In the Matter of DUKE POWER COMPANY
(William B. McGuire Nuclear Station, Units 1 and 2)
Docket Nos. 50-369, 50-370

TESTIMONY OF DOMENIC B. VASSALLO

II QA PROGRAM (ORGANIZATION) AS EVALUATED FOR ISSUANCE OF CONSTRUCTION PERMITS FOR MCGUIRE UNITS 1 AND 2

III QA PROGRAM (ORGANIZATION) AS REVISED FOLLOWING ISSUANCE OF CONSTRUCTION PERMITS

FIGURE 2

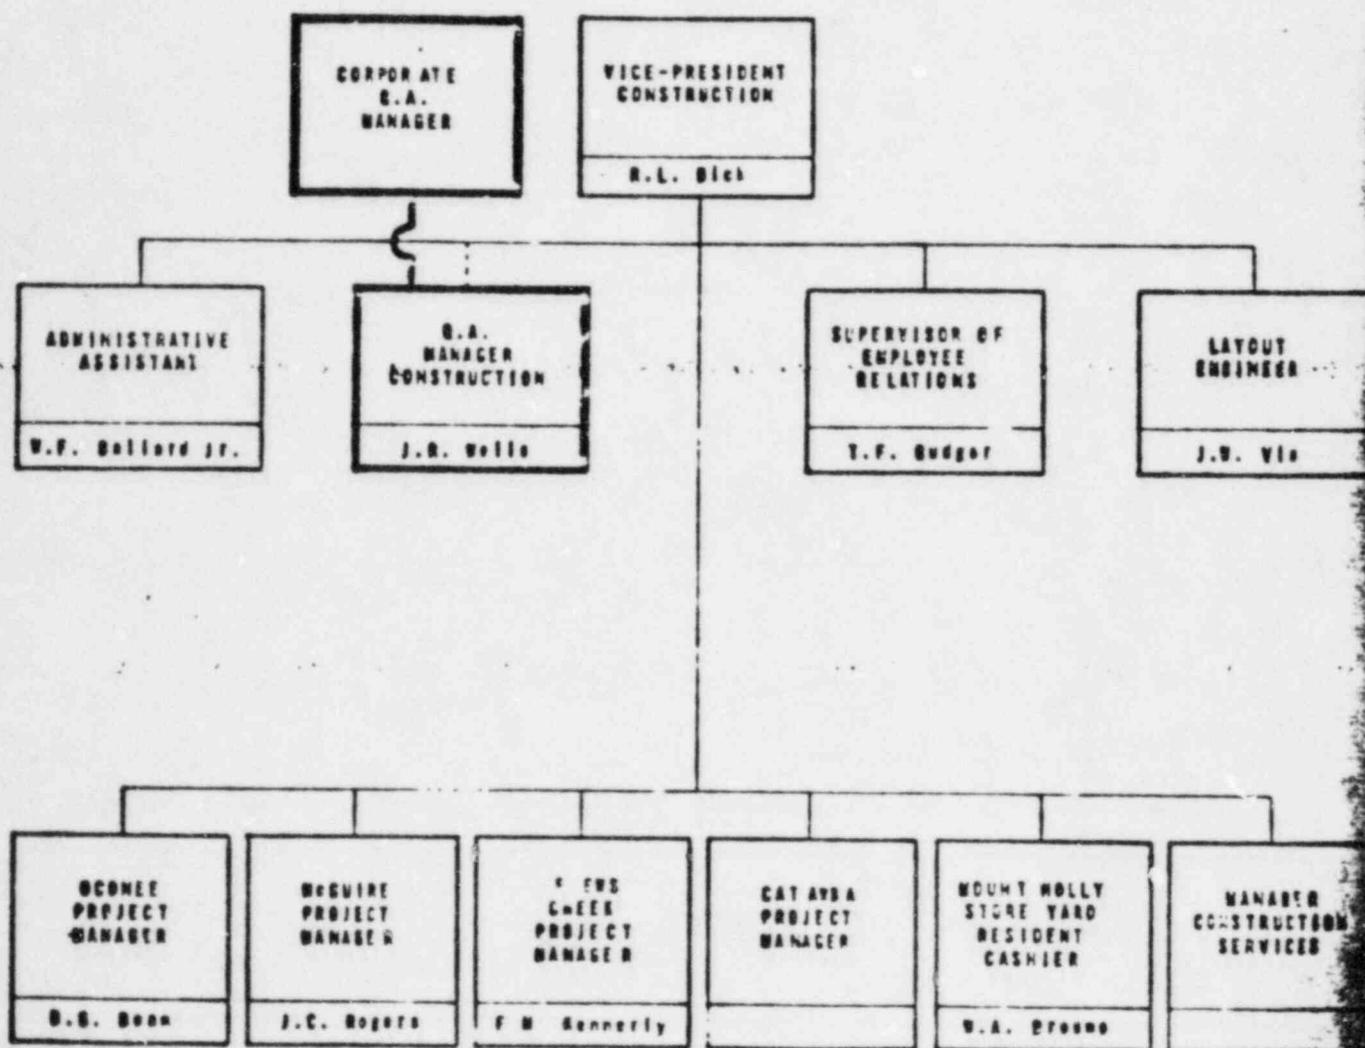
The Construction Department is organized by projects (Figure 2). Each project has a QA Engineer responsible for QA activities at the site reporting administratively to the site project manager and functionally to the Department QA Manager (Figure 3). As in the previous plan, the Principal Field Engineer and his staff, responsible for quality control, is not responsible for the assignment of crafts, the productivity of craft personnel or for meeting job schedules.

FIGURE 1

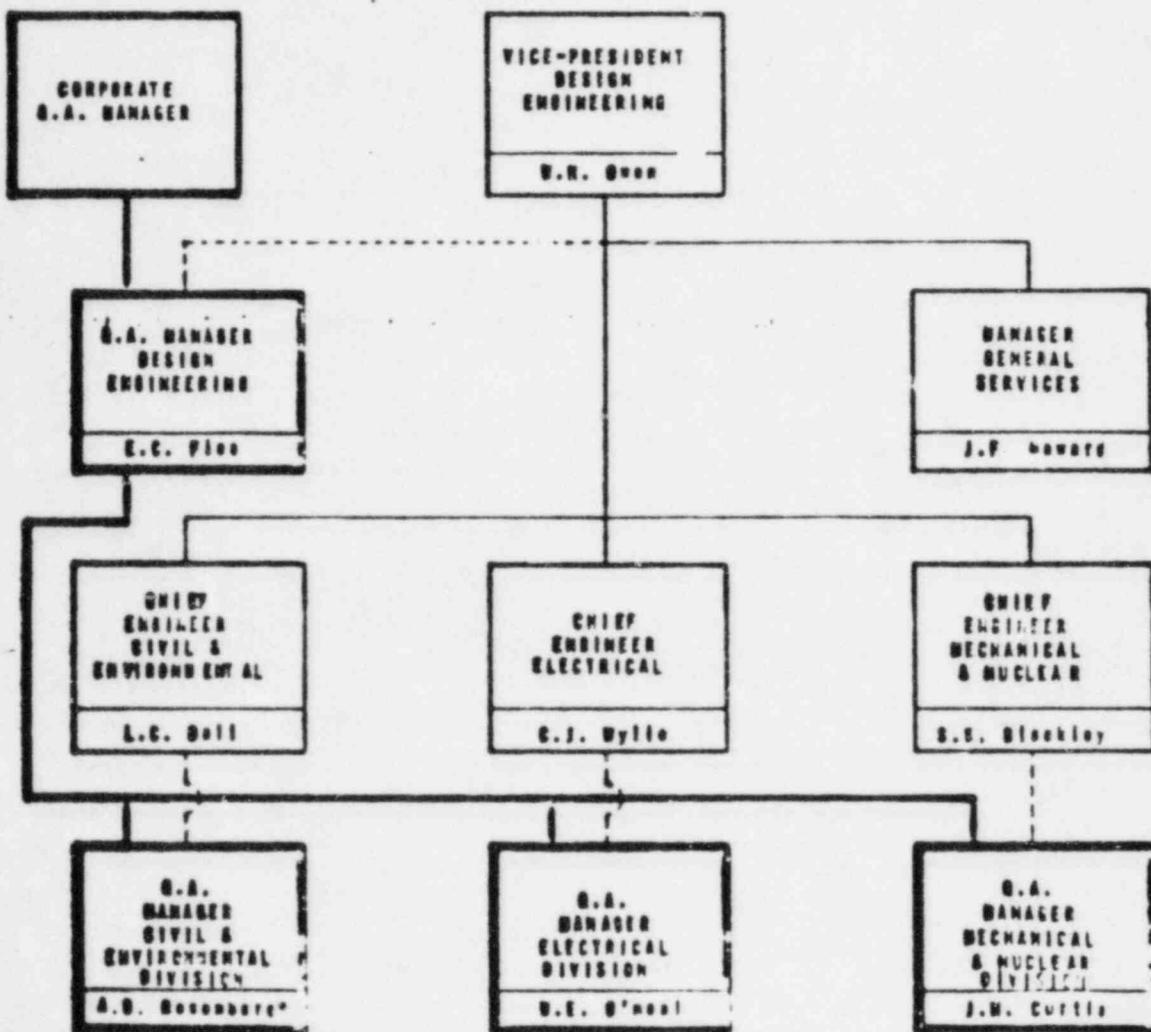
The Duke Power corporate organization is composed of the Design Engineering, Purchasing, Construction, and Steam Production departments. Within the Design Engineering and Construction departments there is a Quality Assurance Manager reporting administratively

to the respective department vice-president, and reporting functionally to the Corporate Quality Assurance Manager, a position currently filled by the Senior Vice President of Design and Construction (Figure 1).

The Design Engineering Department consists of three divisions; Civil, Mechanical and Nuclear, and Electrical. A Quality Assurance Manager is assigned to each division who reports administratively to the division chief engineer and functionally to the department quality assurance manager. Each division quality assurance manager is provided with a staff for implementation of the division's QA program. The QA manager in the Mechanical division has the additional responsibility of vendor surveillance and audit.

FIGURE 4

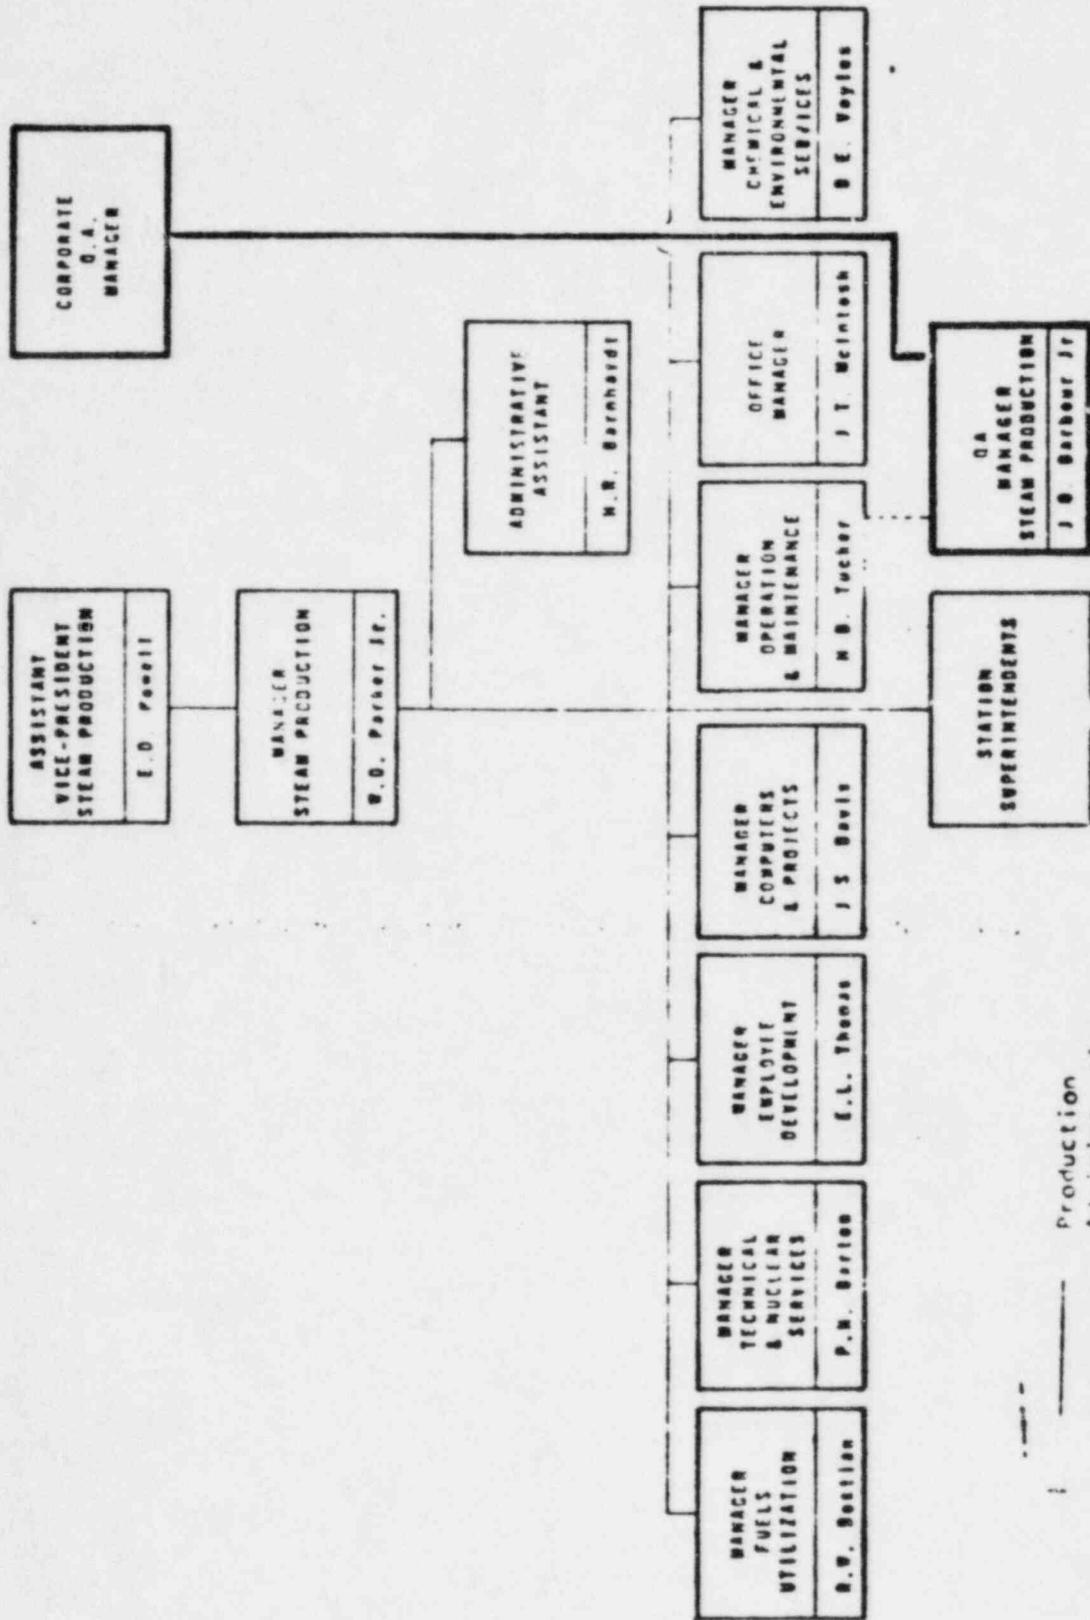
The Steam Production Department is responsible for all operating station functions. A QA Engineer is assigned to each operating station and reports administratively to the Assistant Station Superintendent and functionally to the Department QA Manager. In turn the Department QA Manager reports administratively to the Manager, Operation and Maintenance and functionally to the Corporate QA Manager (Figure 4).
